# Memorandum

To	Douglas Shire Council and Department of State Development, Manufacturing, Infrastructure and Planning		
From	Sarah Wilson - GHD	Tel	+61 7 5413 8133
Subject	Response to information request from Douglas Shire Council (DSC) and Department of State Development, Manufacturing, Infrastructure and Planning (DSDMIP) Wangetti Trail SP1 - Combined Development Application Response to request for information 1909-13127 SRA	Job no.	4132458

We refer to the Development Application Council Ref: CA3212/2019 and SARA Ref:1909-13127 SRA associated with the proposed Wangetti Trail SP1 and provide responses to the information request issued by Douglas Shire Council (DSC) and Department of State Development, Manufacturing, Infrastructure and Planning (DSDMIP) in accordance with Part 3, Section 13.1 of the Development Assessment Rules.

Print date: 31 Oct 2019 - 12:04

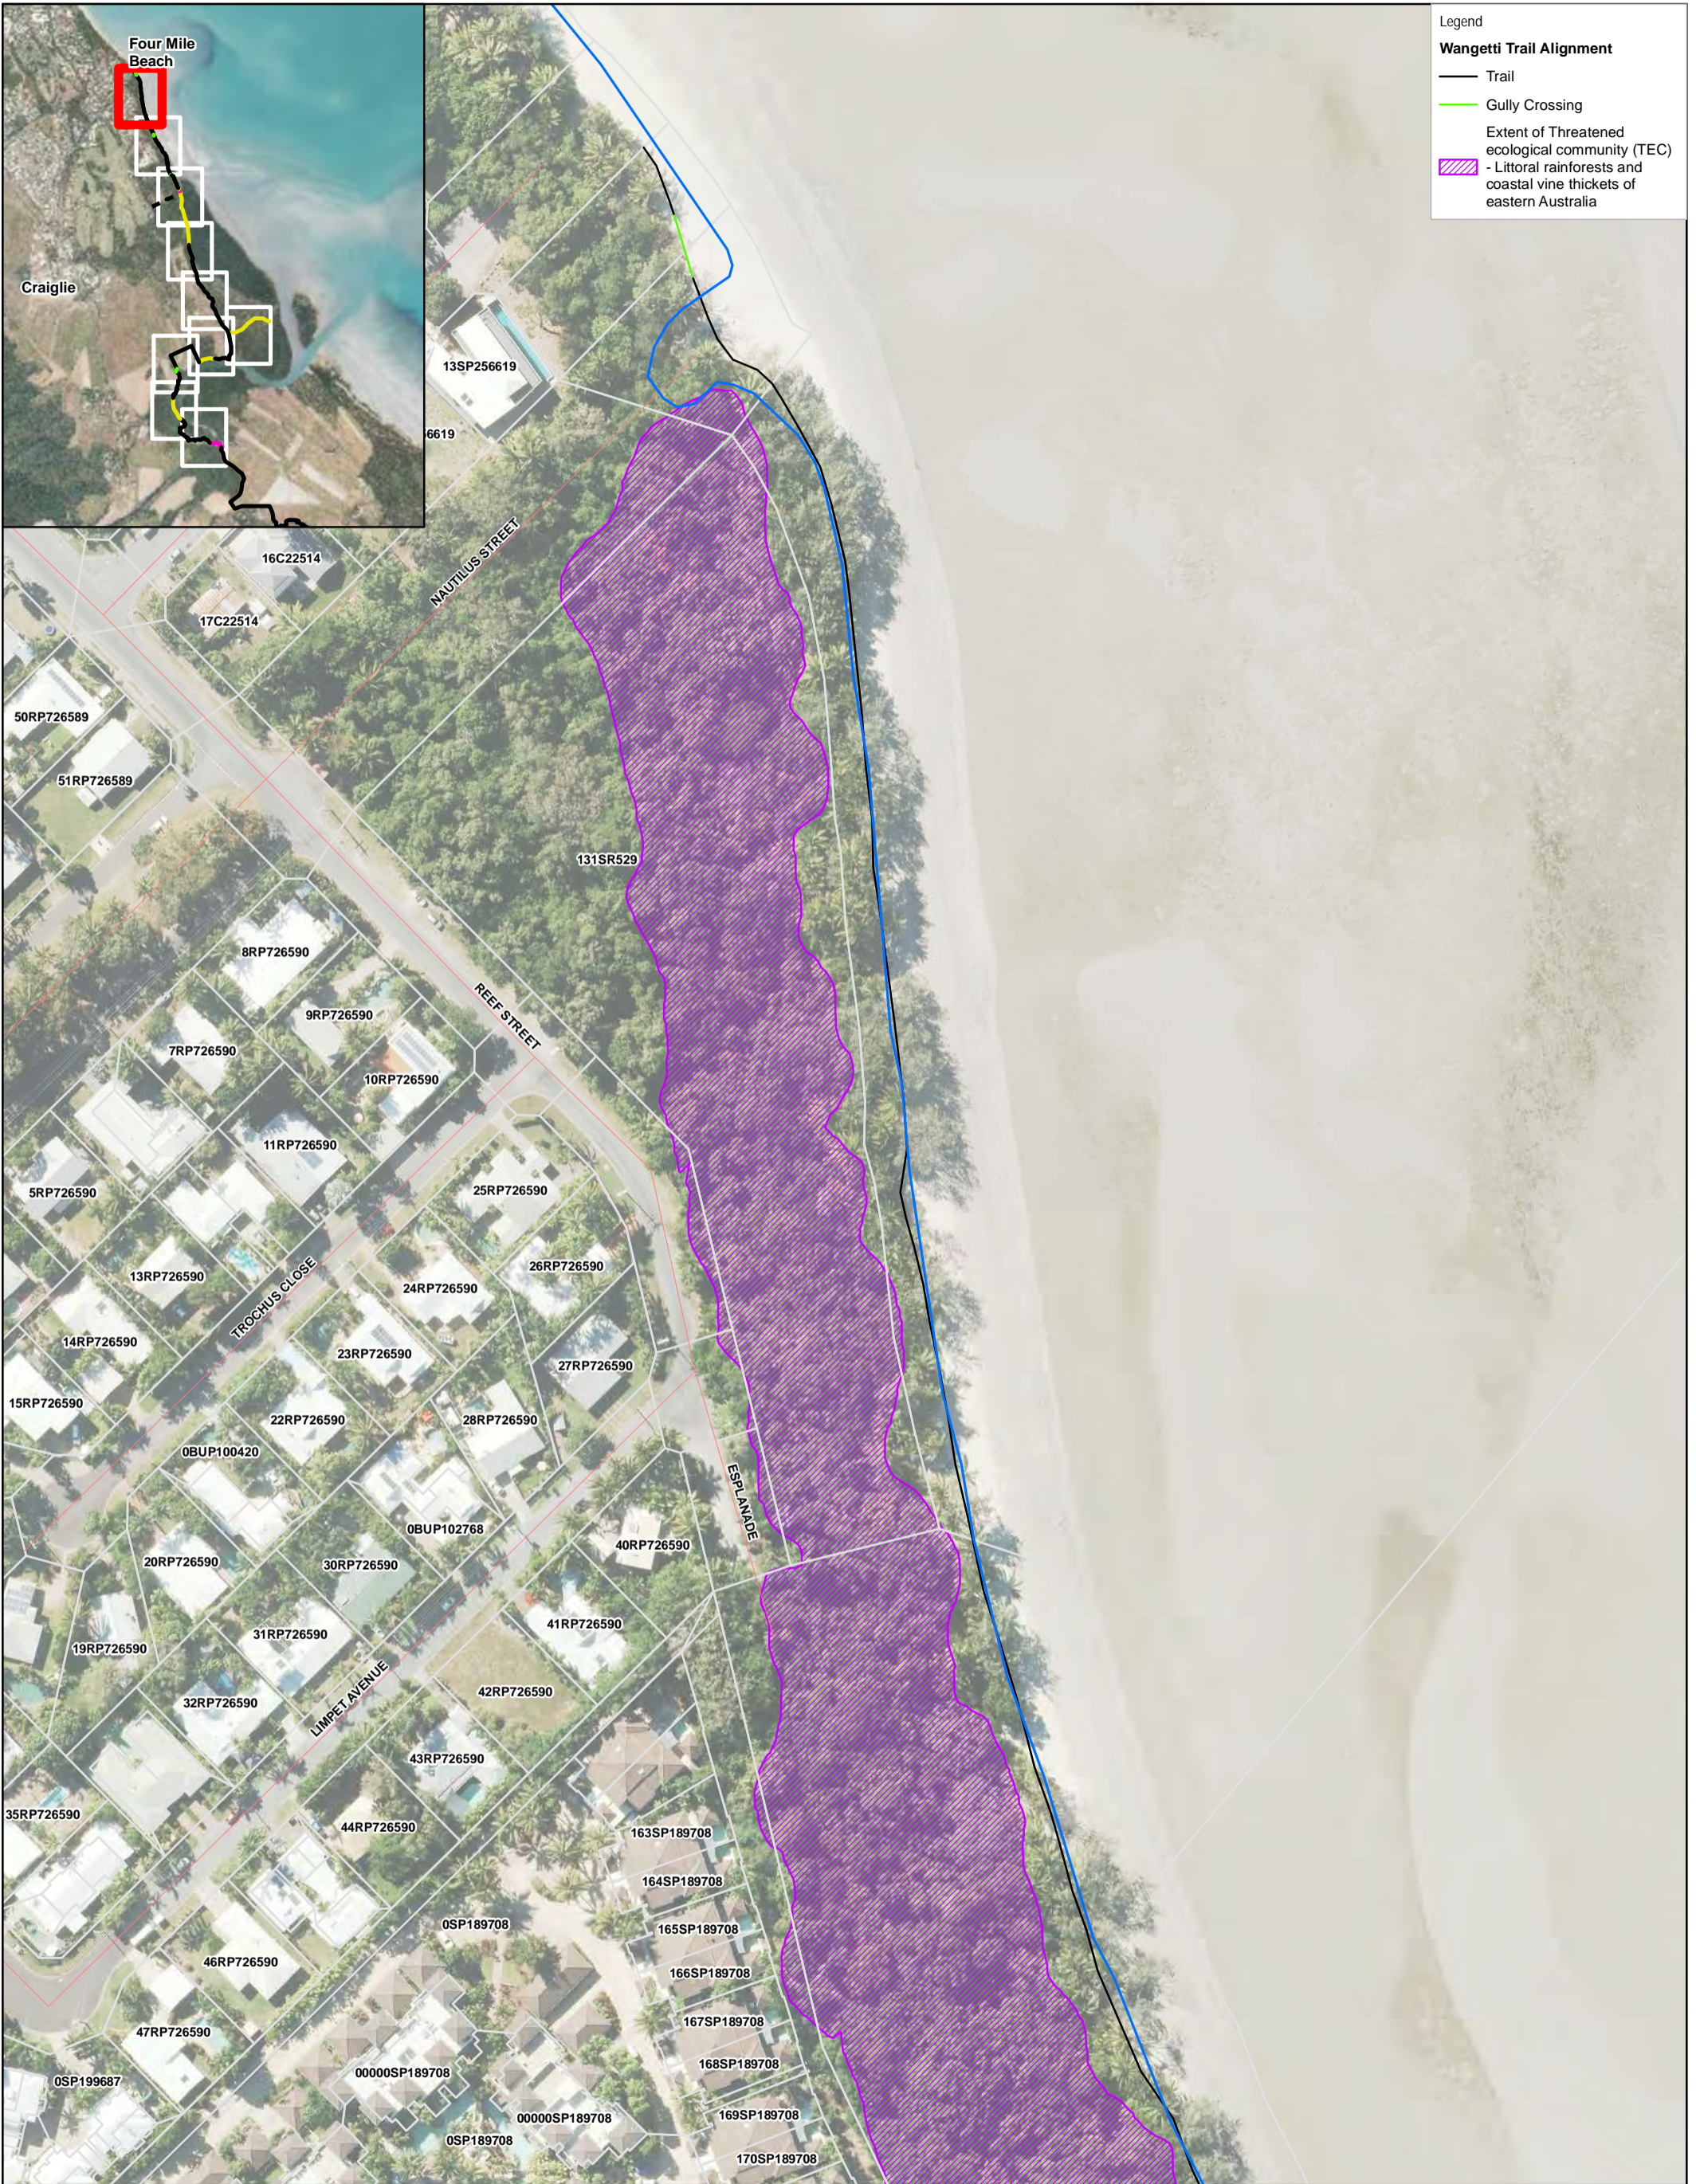
- Identify on scaled maps the trail alignment for Alternative A and Alternative B and provide the permanent and temporary marine plant disturbance areas in meters squares (m<sup>2</sup>).
- Demonstrate that no alternative trail alignments or construction alternatives exist that will avoid impacts on marine plants and fisheries resources (i.e. raised boardwalk).
- Discuss why areas of cleared land, existing informal tracks and land above the level of HAT within Lot 90 on SR678, Lot 87 on SR370 and Lot 24 on SR423 and the road reserve of Captain Cook Highway have not been used for the trail alignment.

### Response to Item 1 (a) Identify on scaled maps the trail alignment for Alternative A and Alternative B and provide the permanent and temporary marine plant disturbance areas in meters squares (m<sup>2</sup>).

As discussed in Section 3.3 of the SP1 Wangetti Mowbray North Marine Plant Report 2019, multiple alternatives were considered as part of the trail and boardwalk alignment. Alternative A and Alternative B are depicted on Figure 1. A description of the alternative alignments have been discussed in Table 1, including a breakdown of Permanent Marine Plant Disturbance (PMPD) and Temporary Marine Plant Disturbance (TMPD) for alternative alignments vs chosen alignment.

The initial design incorporated a loop where the trail branches off the main trail within Lot 5 on AP13754 (Refer to **Figure 1**). This has been changed to a single branch to substantially reduce the area of impact on marine plants. Other design, maintenance and restoration measures proposed to minimise and mitigate impacts on marine plants are outlined below:
